Value Engineering Study Report

Campbellsville Bypass

Kentucky Transportation Cabinet

Item Nos: 4-142.20 and 4-142.30

Figure 1-2

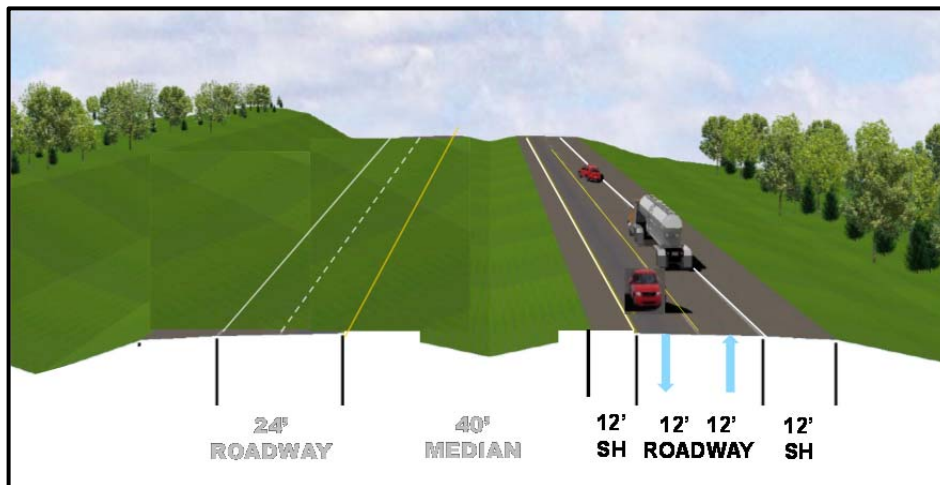
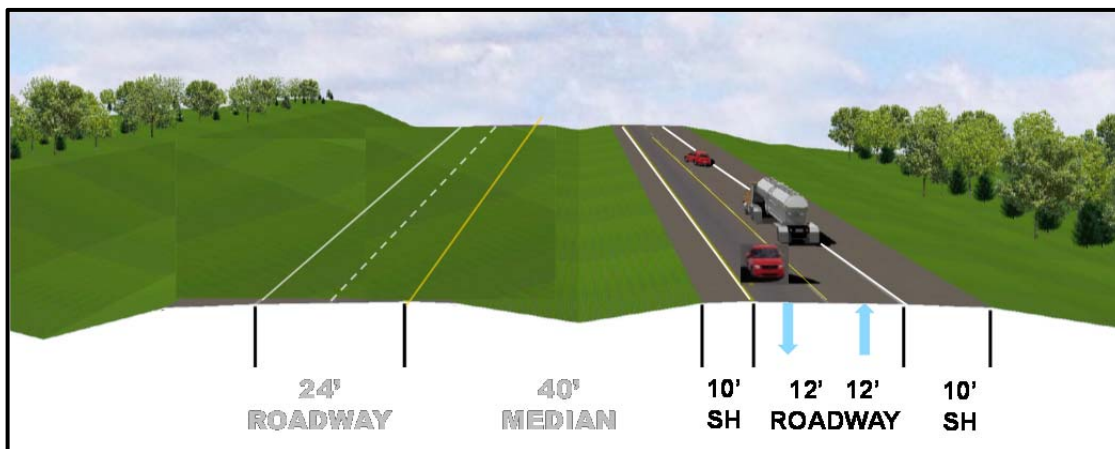
The purpose of the recommendation is to modify the shoulder width to a 10-foot shoulder (8' paved and 2' earth).

It is noted that the approved Design Executive Summary (DES) recommended that additional discussion of shoulder widths be held during Phase 2 design as a result of input from the KYTC Division of Design in Design Memo 2-14.

Figure 2-1: Bridge Typical Sections

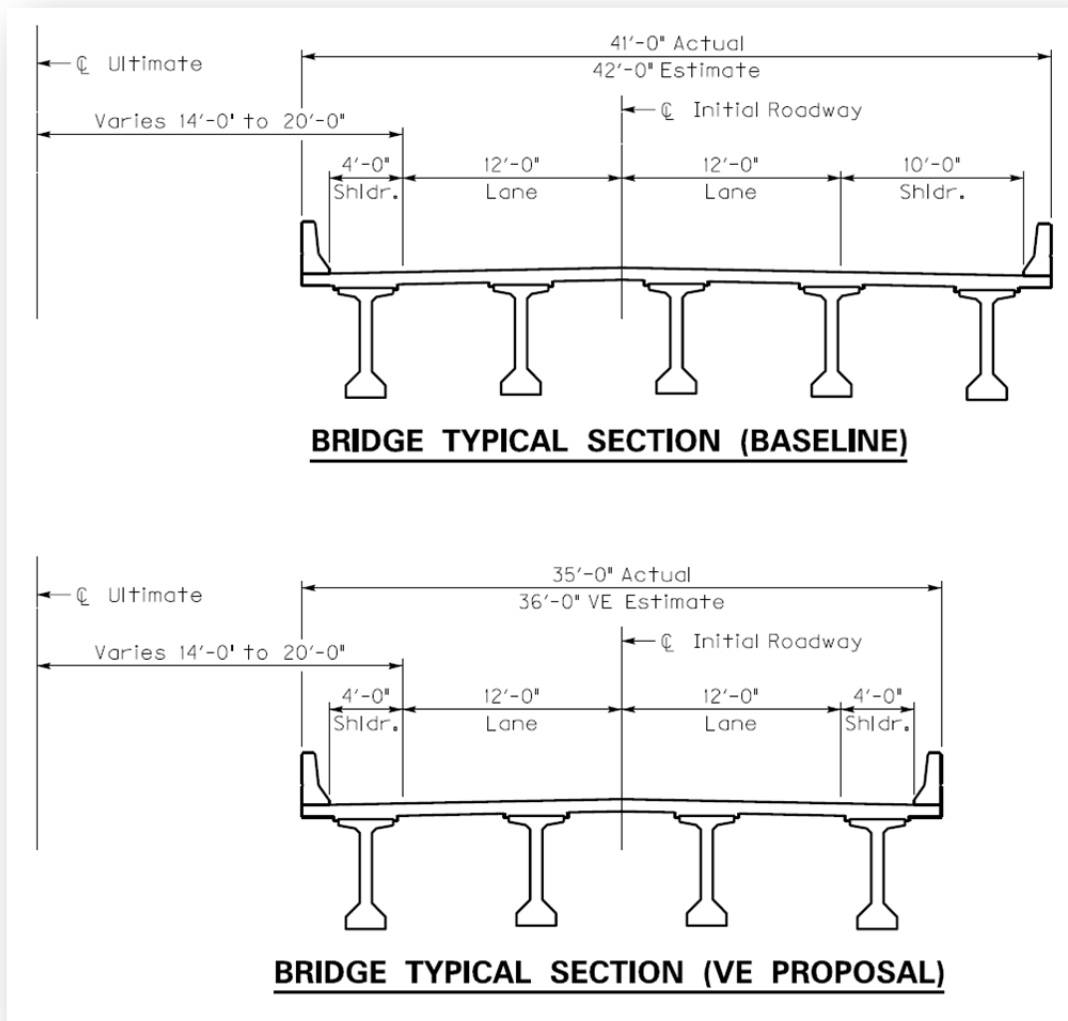
It is not 100 percent clear whether or not the intent was to have an asymmetrical bridge for the 2-lane interim condition. Based on the provided cost estimates and plan views, it appears that the bridges to be built for the 2-lane interim condition are planned to be the required geometry for the 4-lane ultimate condition – meaning that the shoulder on one side would only be 4 feet wide even though the roadway approach leading to the bridge is planned to be built with 10-foot shoulders on both sides for the 2-lane interim condition. If this was an oversight and the intent was to build the interim 2-lane bridges with 10' shoulders on both sides, then the anticipated cost savings would be double what is shown above.

KYTC Design Memo 2-14 states: "The minimum useable shoulder widths should be continued across all new structures. Per AASHTO Guidance, on long bridges (in excess of 200") it may be acceptable to have bridge shoulder widths less than the approach roadway shoulder widths." Chapter 7 of AASHTO (page 447) further states: "On long bridges, offsets to parapet, rail, or barrier should be at least 1.2 m [4 feet] measured from the edge of the traveled way on both sides of the roadway."

Figure 3-2

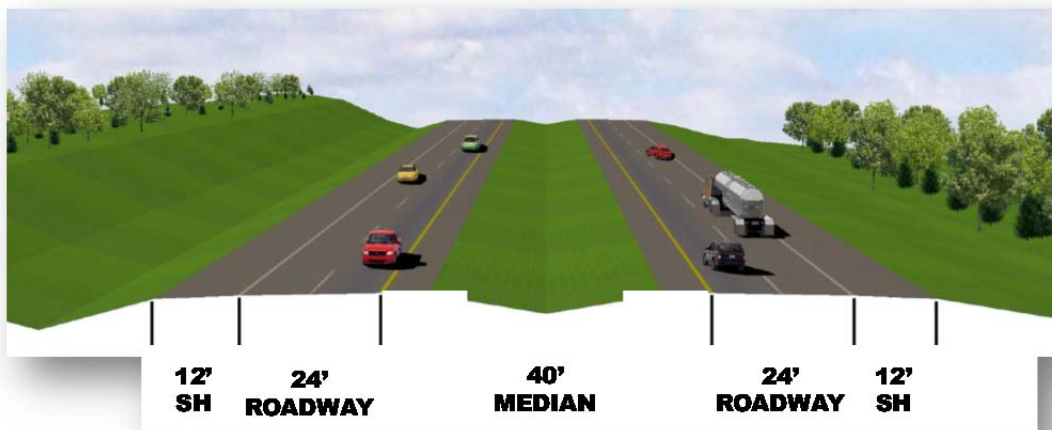
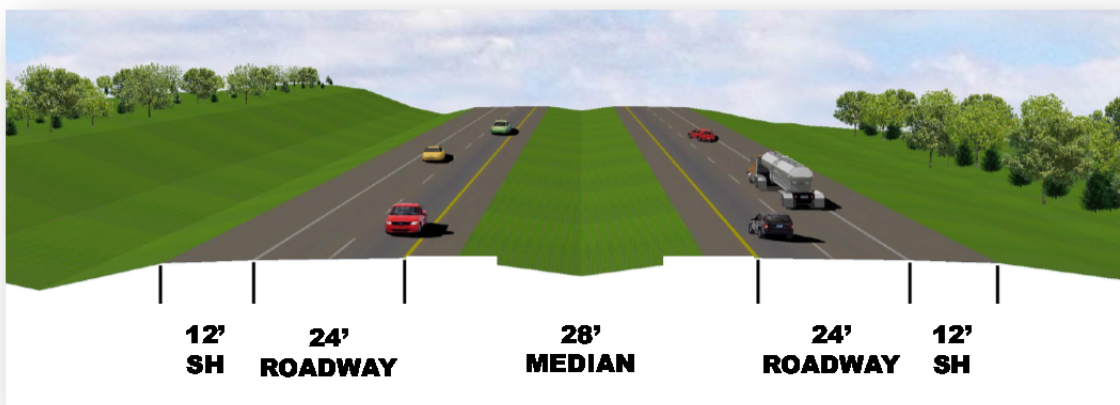
The VE recommendation is to reduce the median width from 40 feet to 28 feet, which satisfies the clear-zone requirements and is being used on other KYTC projects. Changing the median width and right-of-way to accommodate a 28-foot median reduces the overall right-of-way area required, thus reducing initial costs and long-term maintenance. An added benefit to this concept is a reduction to the overall foot print for the project, reducing environmental impacts.

Figure 4-2

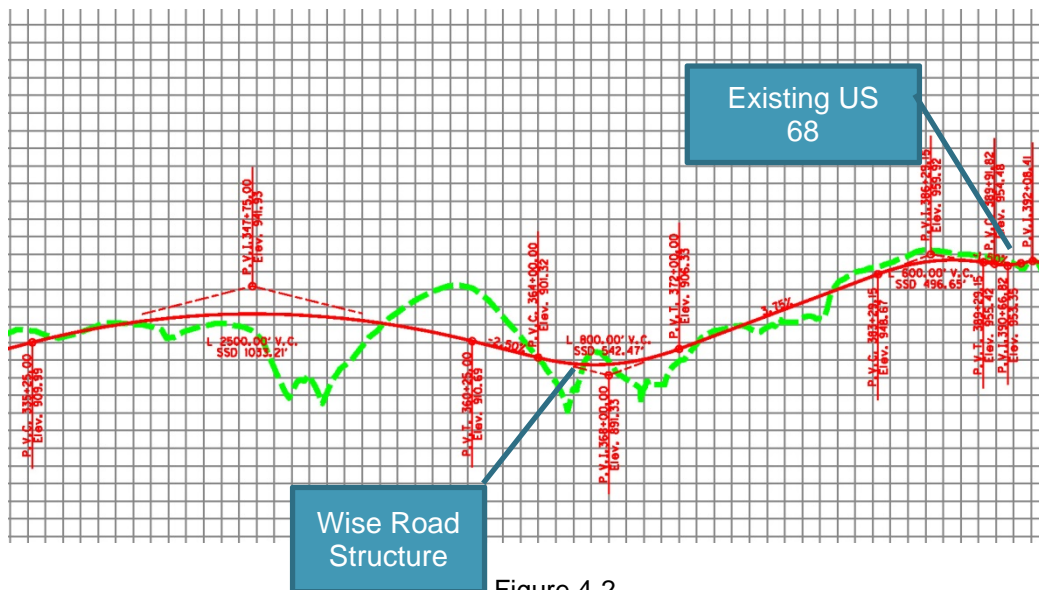
As shown on Figure 4-1, the current baseline concept crosses Wise Road at a location that requires a structure due to the grade differential and steep slopes adjacent to Wise Road. In addition, the grade of Wise Road in this vicinity is approximately 10 percent (downgrade to the lower right in photo). Access to the bypass from Wise Road is not provided.

Figure 4-2 shows the current baseline bypass profile at this location. For information, the proposed grades on the bypass on either side of the structure are -2.5 percent and +3.75 percent.

Figure 4-4

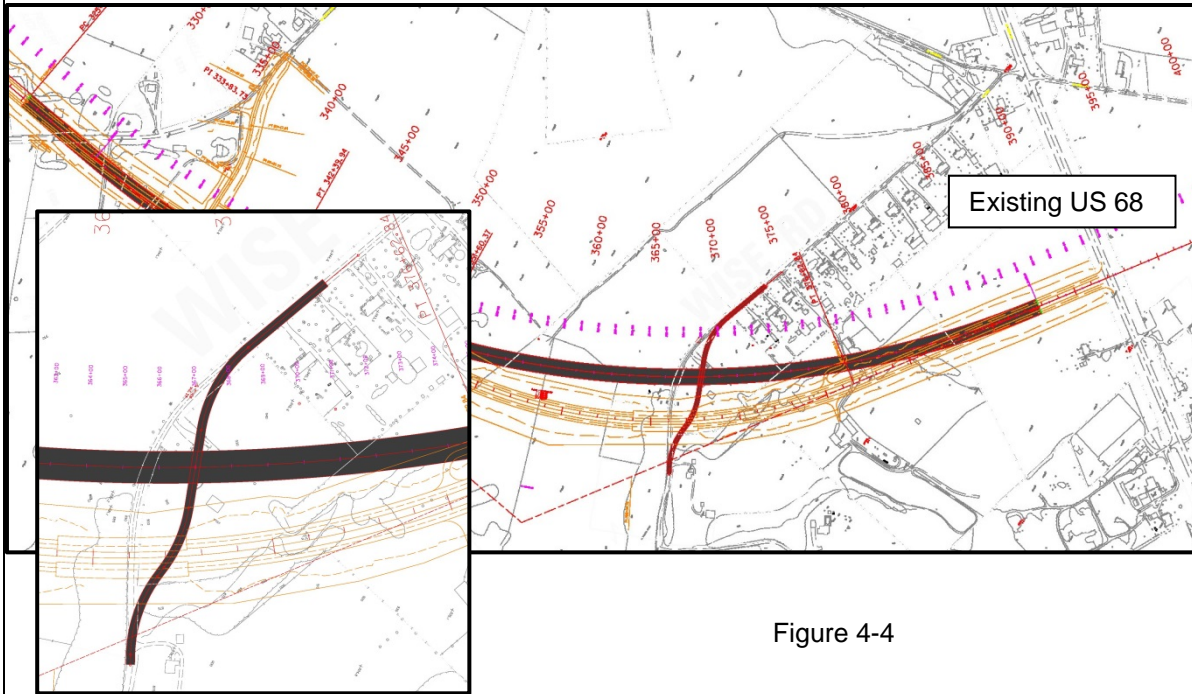
After evaluation, the team focused on an adjustment that shifted the alignment to the north by lengthening the radius of the curve (from 2,500 feet to 5,100 feet). This modification crosses Wise Road approximately half way between the “yellow” (baseline) and “light blue” alternative.

The proposed recommendation is shown on Figure 4-4.

Figure 4-5

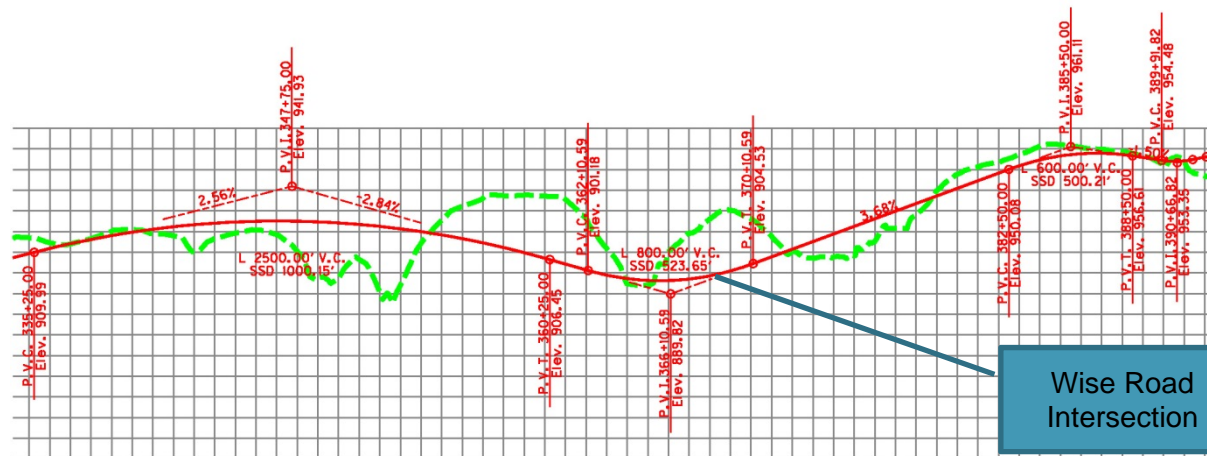
Figure 4-5 shows the recommended bypass profile at this location. For comparison, the proposed grades on the bypass on either side of the structure are -2.85 percent and +3.70 percent (similar to baseline).

Figure 4-6

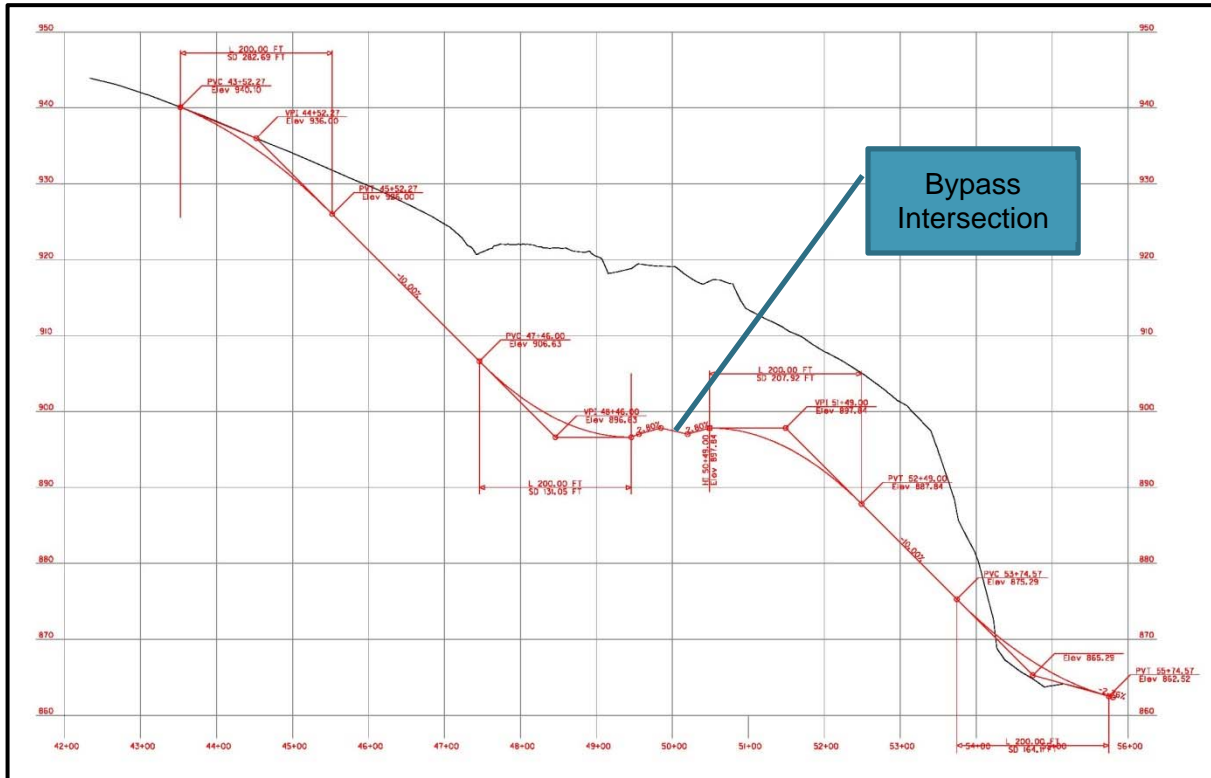
The challenge to this alternative was to meet acceptable design criteria for Wise Road, south of the bypass intersection, with maximum grade and sight distance being the most significant issues. Based on our analysis, we believe these criteria can be achieved, but further verification should be made prior to moving forward with this recommendation. It is noted that sight distance for Wise Road is based on a 25 mph design speed. The recommended Wise Road profile is shown on Figure 4-6.

Figure 6-1. Bridge 1 Profile

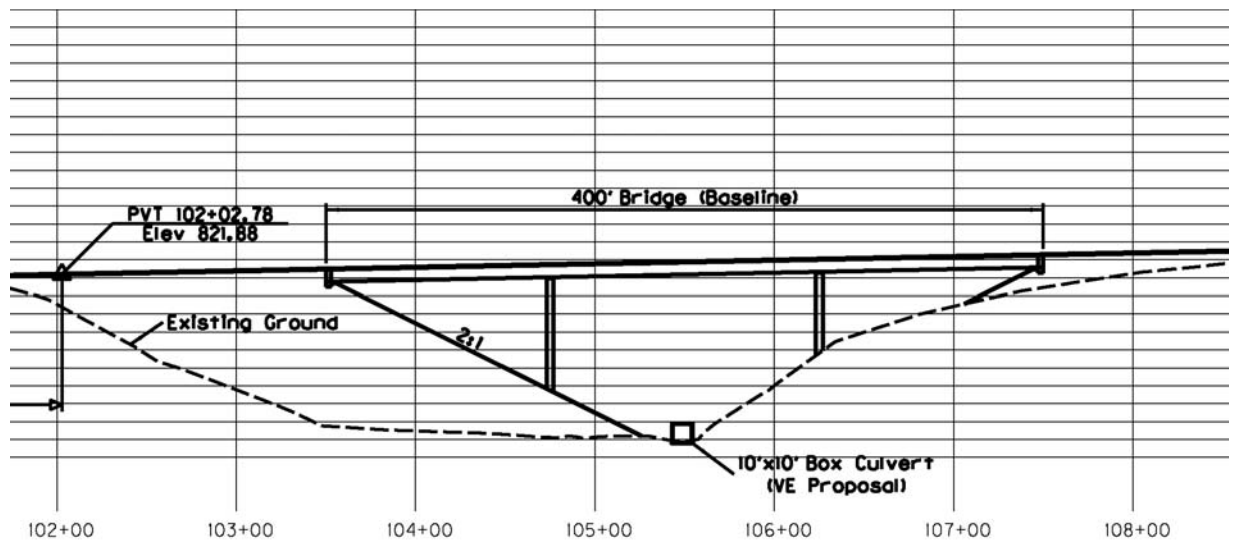
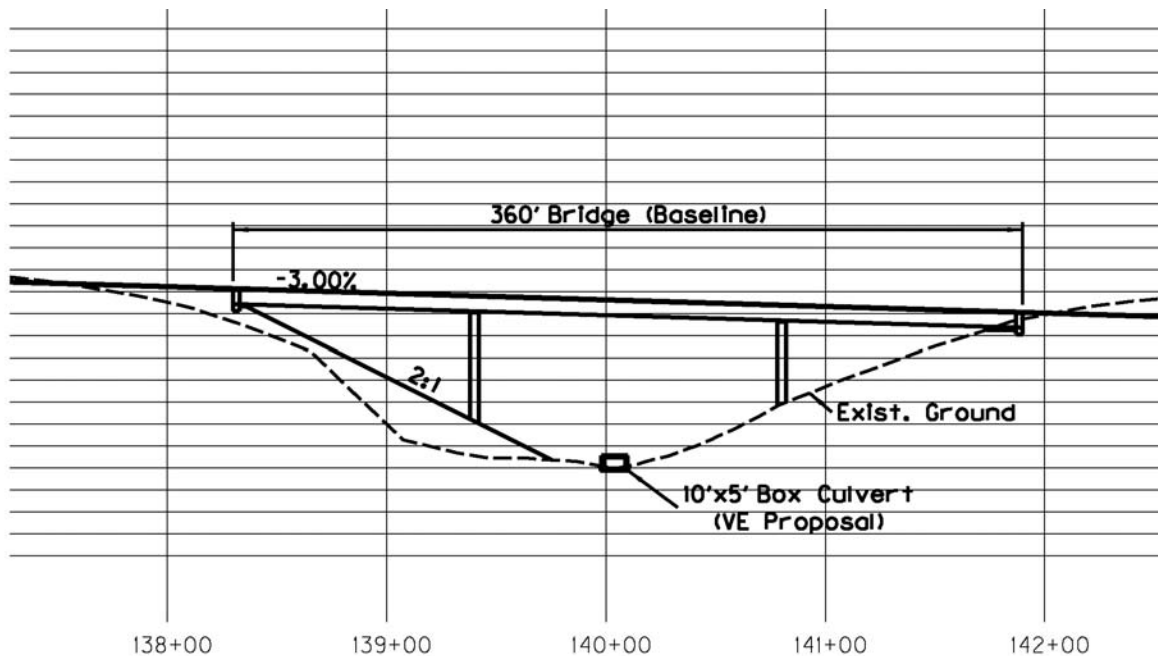
The logic for establishing the bridge limits in the baseline were not fully understood. An attempt was made to lay out a theoretical bridge with 2:1 spill slopes in the profile for Bridge 1 and Bridge 2 based on the bridge limits shown in the provided MicroStation files. This was then used as the basis for calculating the additional earthwork needed if the bridges were to be replaced by box culverts.

Figure 7-1

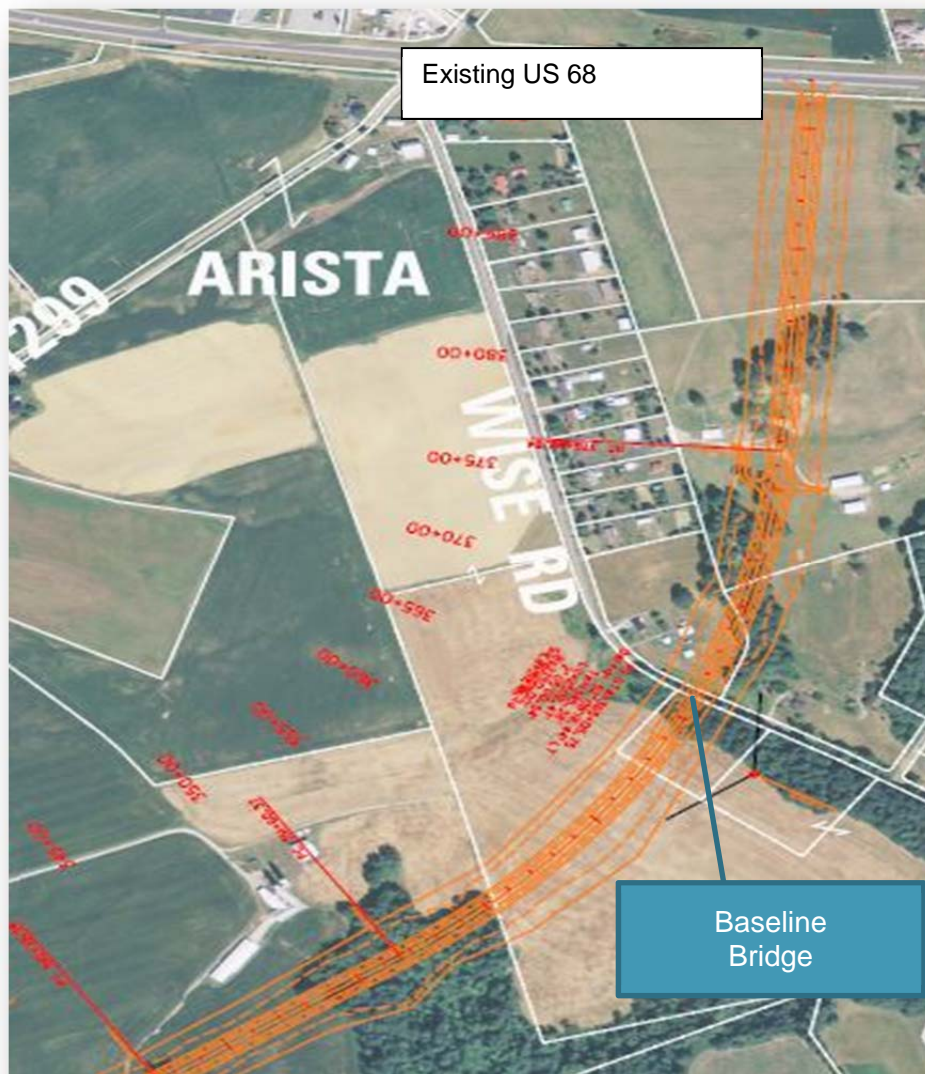
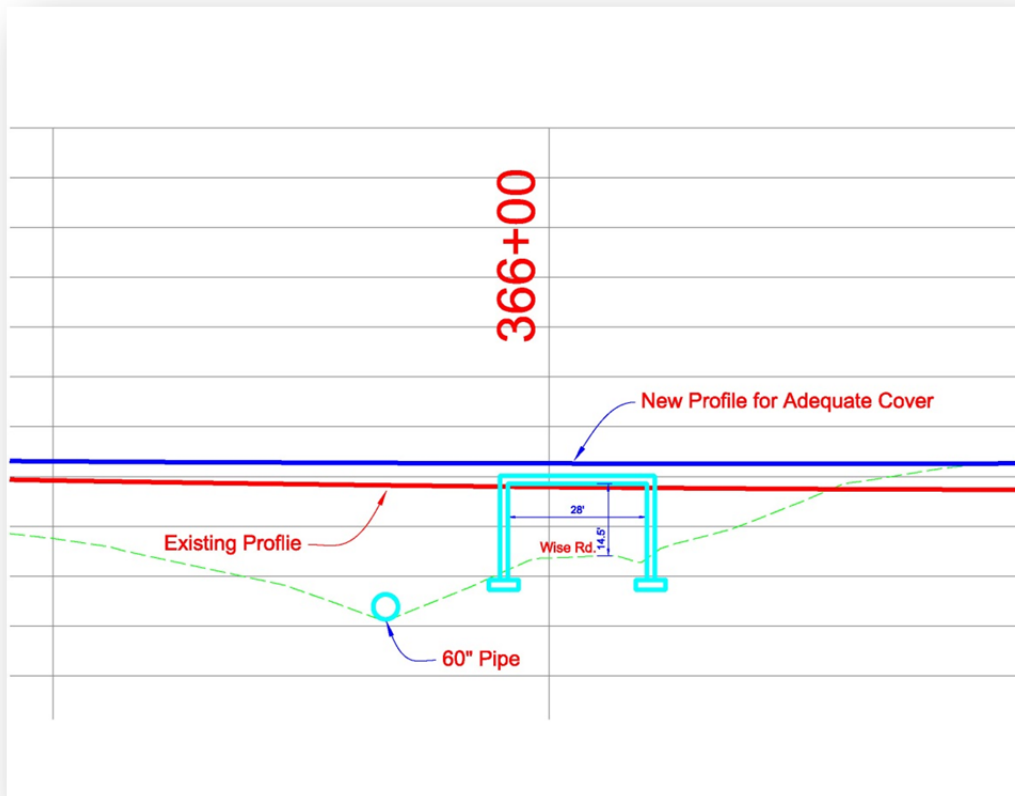
The wagon box structure would provide for a minimum 14'-6" clearance from Wise Road to the top inside of the structure. It would be 28 feet wide to accommodate 11' lanes and 4' shoulders. (The existing road is approximately 15 feet wide). The 60-inch pipe would be located next to the structure to accommodate drainage. It should be noted that the profile would have to be raised in this area to accommodate the clearance criteria, and it should accommodate the future 4-lane construction. However, the profile would have to be raised anyway with the baseline bridge concept due to inadequate clearance over Wise Road as it is currently designed. The wagon box concept offers the advantage of not having to raise the profile as high as would be necessary to get the minimum clearance under the baseline bridge concept.

Figure 8-2

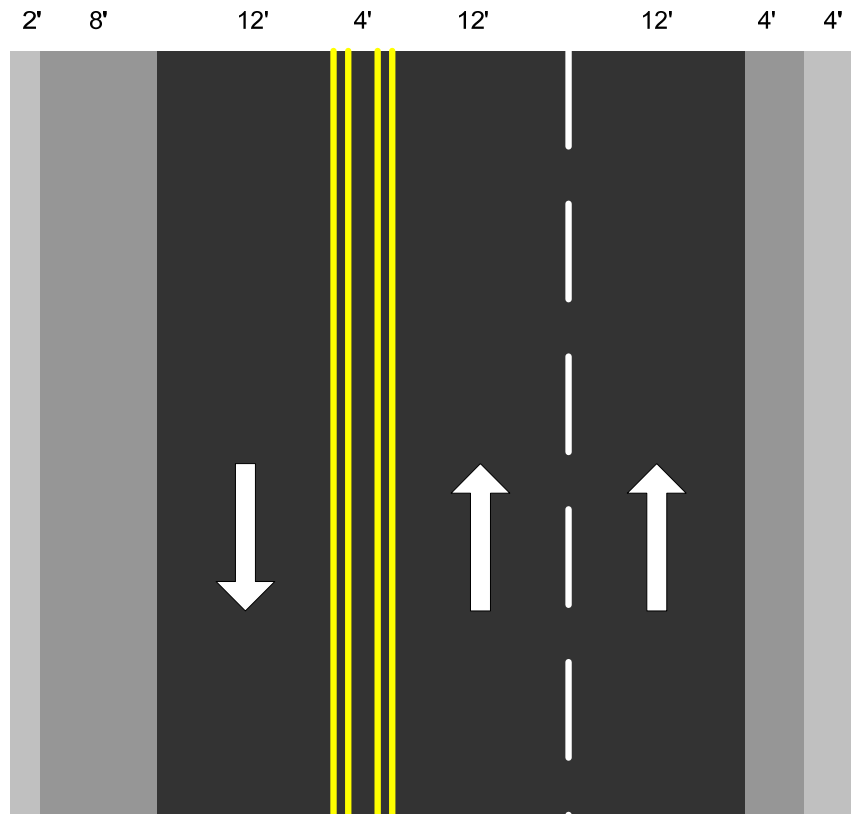
There will be less right-of-way needed compared to the original design. There would need to be an additional 12 feet of pavement compared to the initial 2-lane construction. The design team would need to decide whether to leave this in place and modify (shift) the ultimate additional two lanes, or to take out the 12 feet of width and keep the original 4-lane alignment.

For development of this recommendation, the typical section was assumed to have three 12-foot travel lanes and a 4-foot flush median. Shoulders are 8' paved in one direction and 4' the other. The structures would be widened 16 feet to accommodate the passing lane and median. The project team has the option to reduce the cross section, such as reducing the shoulder widths, to reduce construction costs.
